ADDENDUM

December 15, 2017

RFB NO. 317028 - ADDENDUM NO. 1

SCHUMACHER BARN REMODEL/SITE IMPROVEMENTS (REBID)

$$\text{WHERE: } A = \frac{B - (C + D + E)}{F} \times 100$$

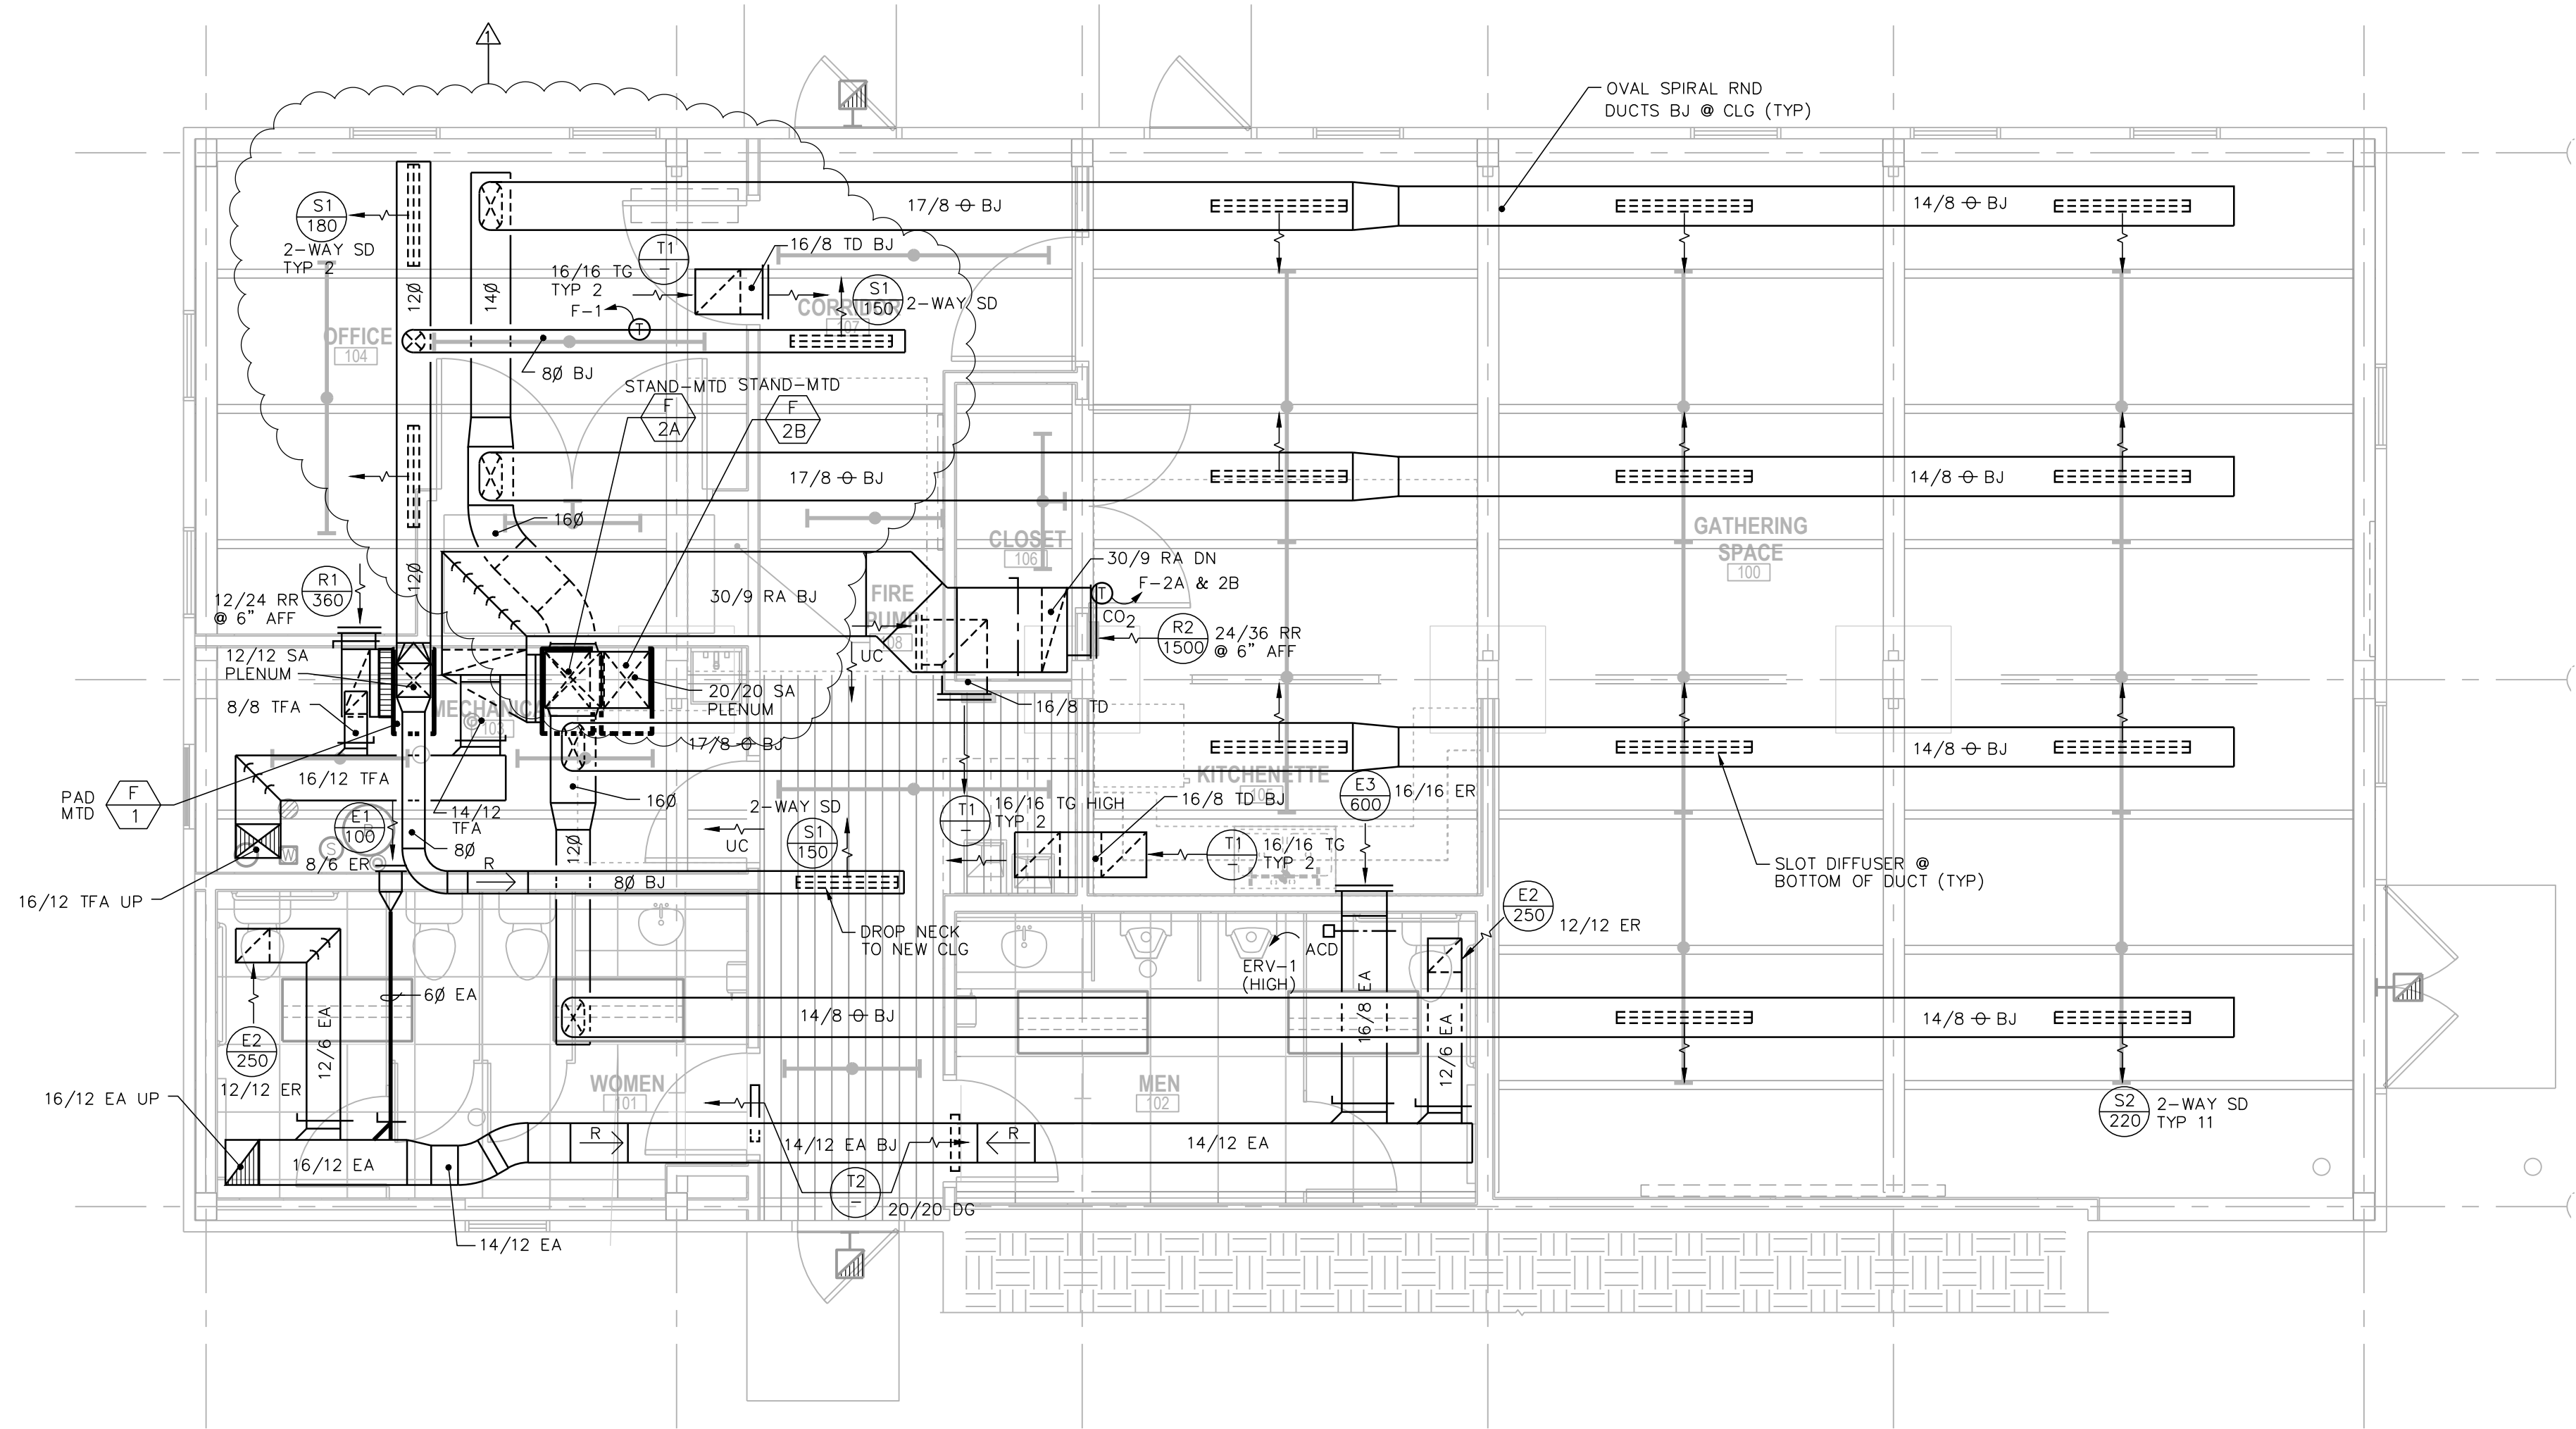
28. Sheet P2.0 - PLUMBING RISERS, SCHEDULES & DETAILS

Delete current Sheet P2.0 and replace with new Sheet P2.0, issued with this Addendum.
Modified water pressure service to 32 psig and related water sizing calculations.
Modified waste and water risers.

1 FIRST FLOOR PLAN - RADIANT FLOOR PIPING
 1/4" = 1'-0" NORTH

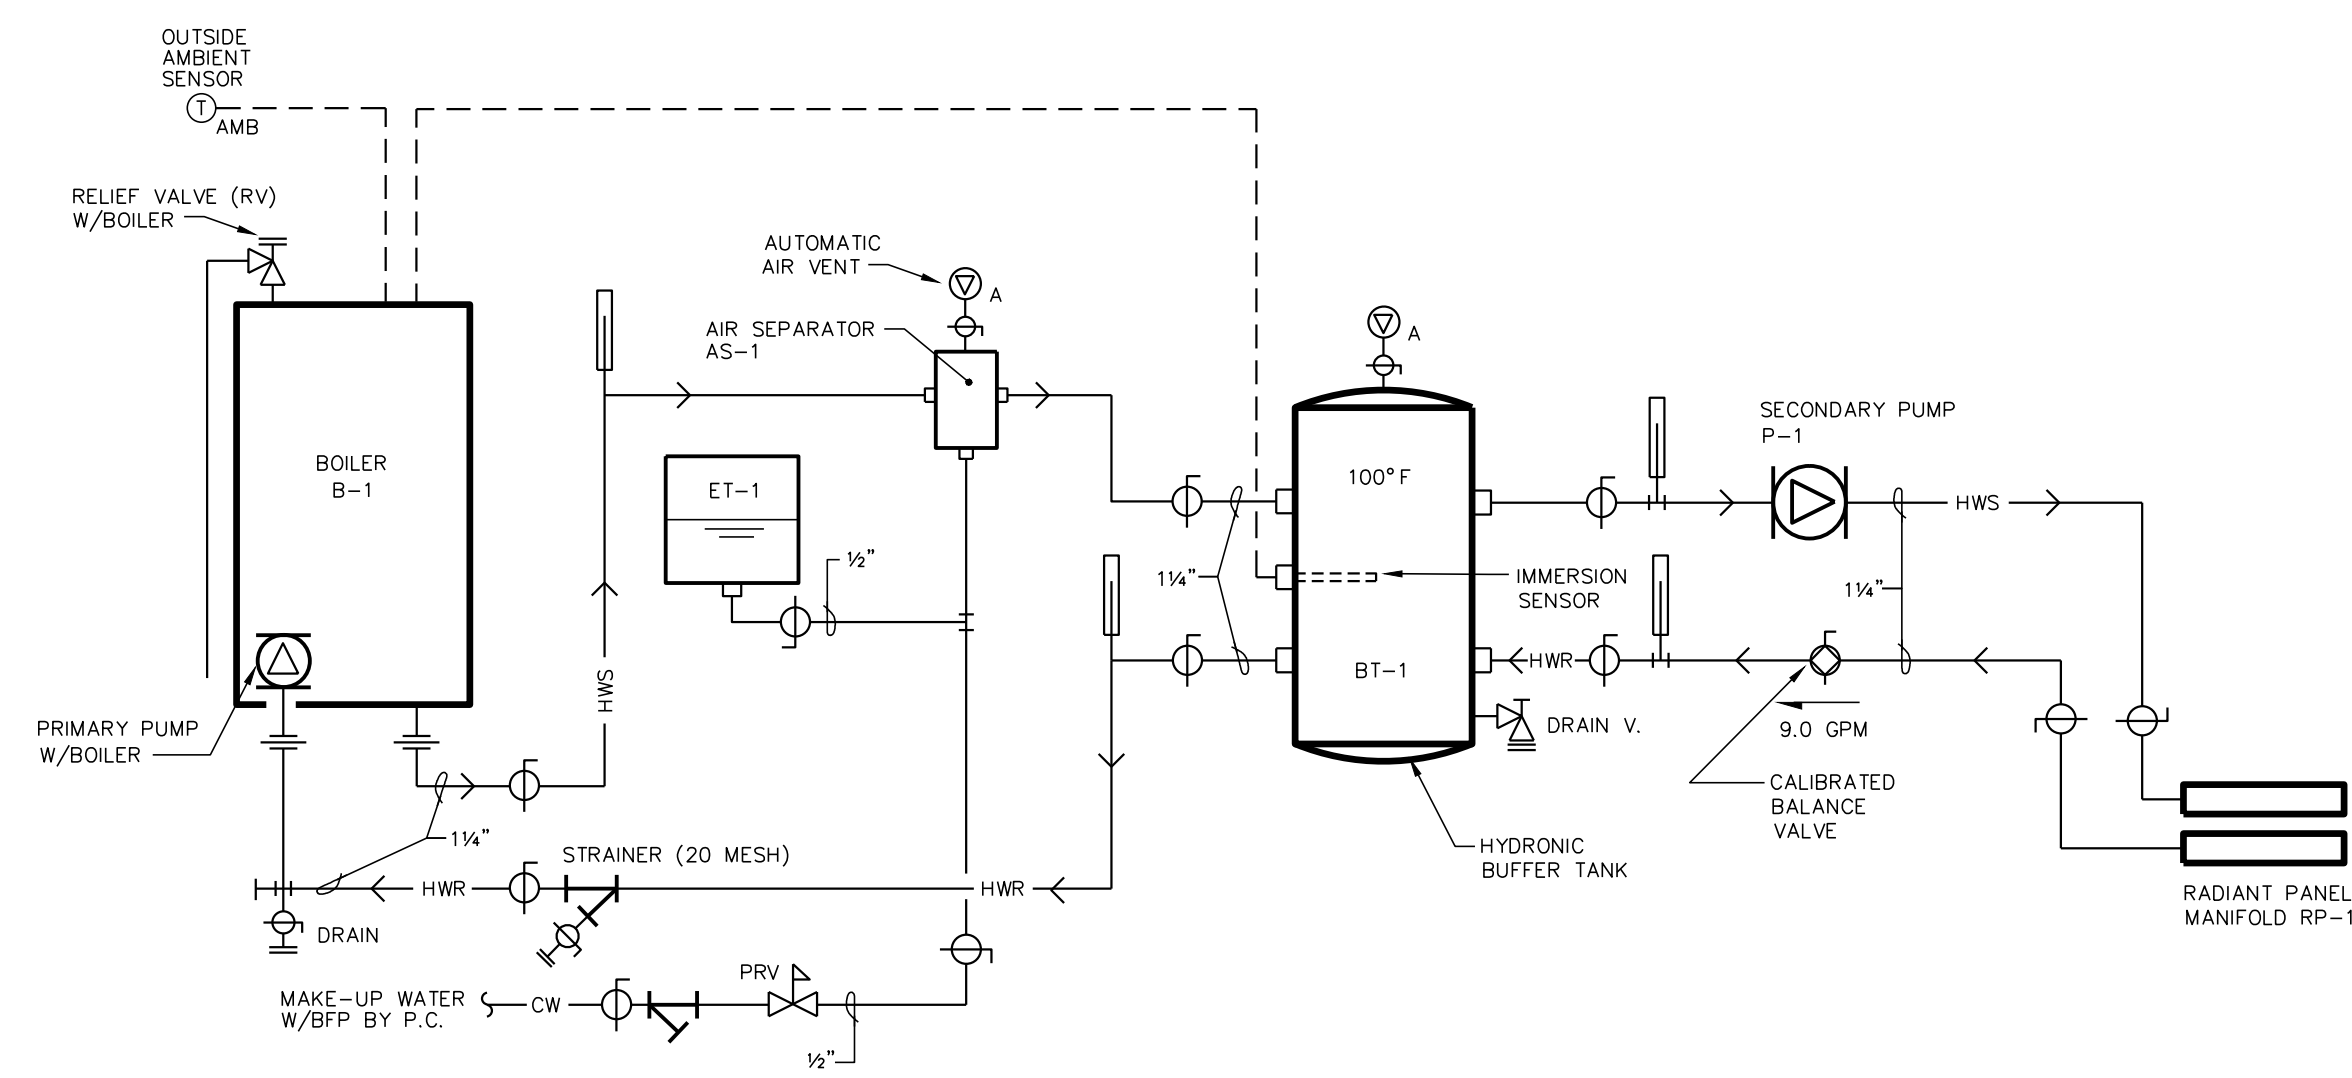
30. Sheet H1.3 - GROUND FLOOR PLAN – RADIANT HEAT

Delete current Sheet H1.3 and replace with new Sheet H1.3, issued with this Addendum.
Modified radiant floor for Fire Pump 108.

1 FLOOR PLAN - ELECTRICAL LIGHTING
1/4" = 1'-0"

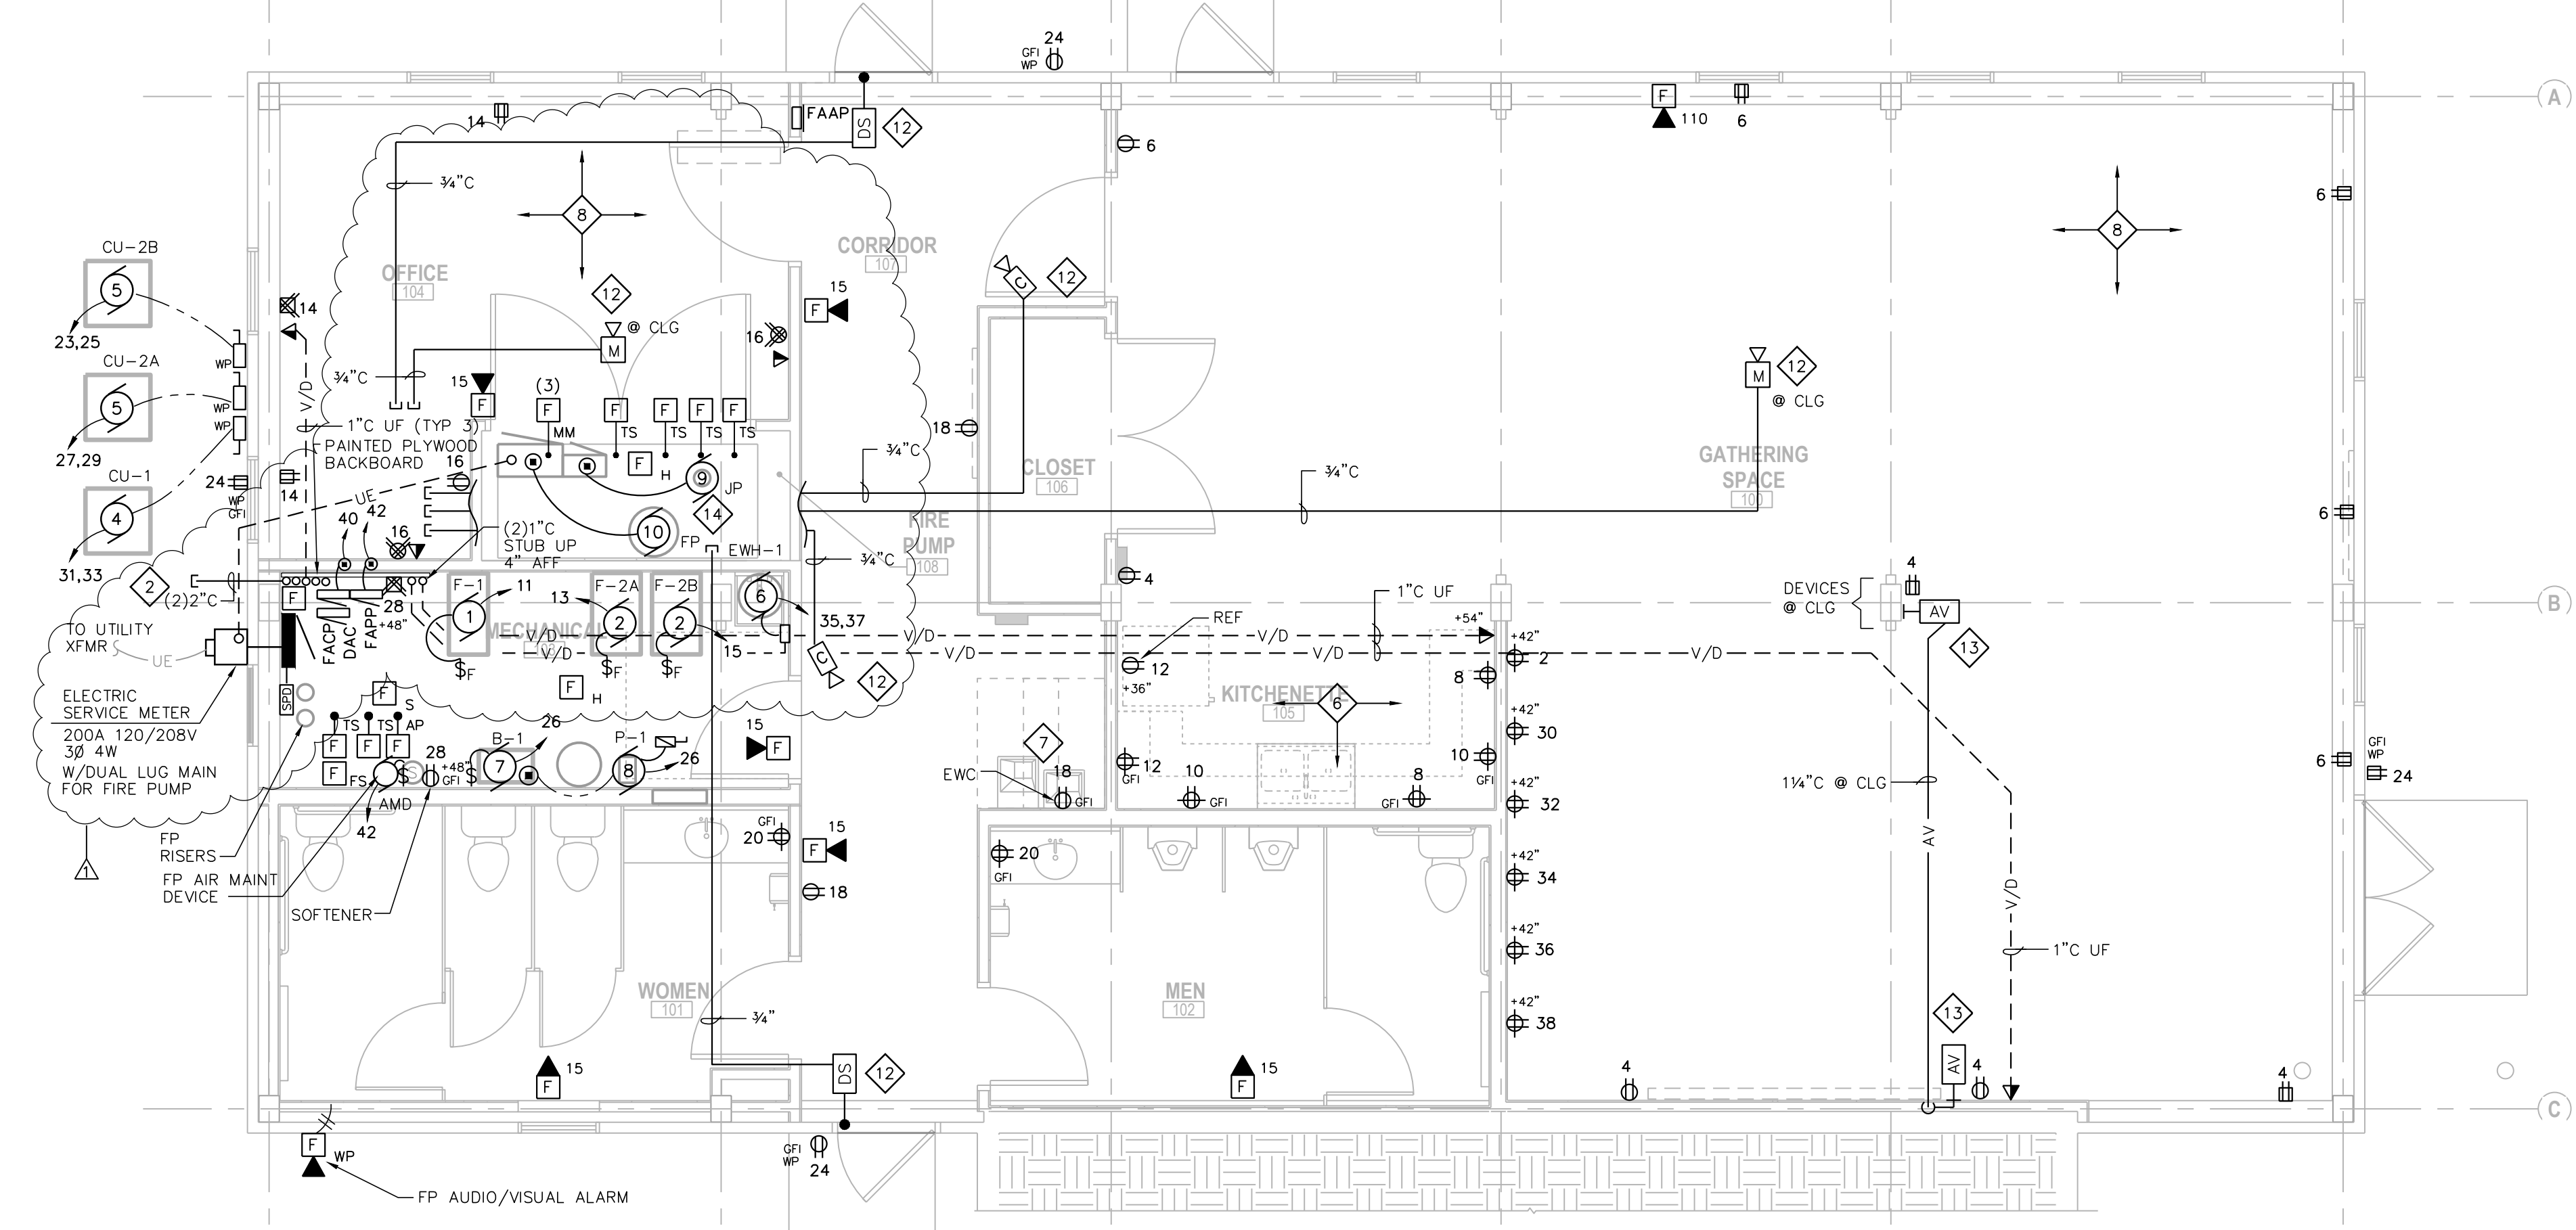
32. Sheet E1.1 - GROUND FLOOR PLANS - ELECTRICAL

Delete current Sheet E1.1 and replace with new Sheet E1.1, issued with this Addendum.
Disconnect existing 1-phase service and panelboard.
Revised electric service to 3-phase with fire pump feeder.
Modified electrical plans for Fire Pump 108, fire and jockey pumps, and related fire alarm requirements.
